Technical Note 2

| Title | Rebuttal to SGC Highways Comments on application P21/03344/F. | | | | |

Road Safety Audit - Badminton Road, Old Sodbury

| Report Title: | Stage 1 road safety audit, A432 Badminton |

Appendix B: Key Plan showing scheme proposals

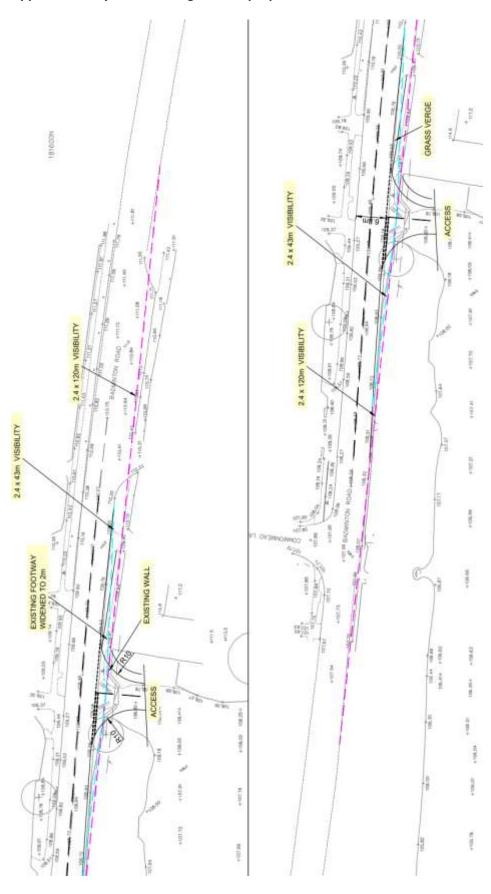
- 2. Safety Issues Raised in this Stage 1 Road Safety Audit. (see Appendix B for locations)
- 2.1 No road safety issues were identified by the auditors
- **2.2** In response to the Local Highway Authority's concerns, the auditors provide the following comments:

3.1 No provision has been made for pedestrians to cross the A432 between the development and the eastbound bus stop. Recommend pedestrian drop kerbs and tactile slabs are included in the scheme to provide an informal crossing point.
